The Red Flash

News from our laparoscopic products

Multifunctional Plastic Handle For Laparoscopic Instruments

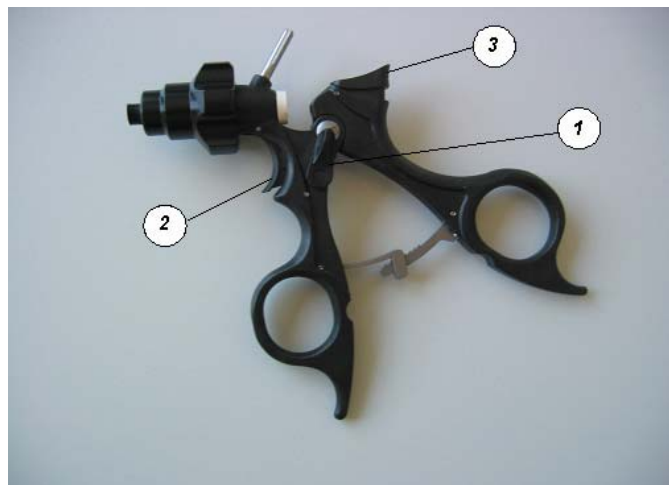
As per now we will deliver the following instrument for article numbers H43-...

With this new plastic handle it is possible to work with or without ratchet due to the fact that the ratchet can be deactivated . The deactivation and renewed activation will be effected by a lever (1) on the side of the instrument.

There are two possibilities to loosen the active ratchet: Either by pushing the release button (2) at the front part of the handle (e.g. with the index finger) or by pushing (e.g. with the thumb) an additional release button (3) on the upper part of the handle.
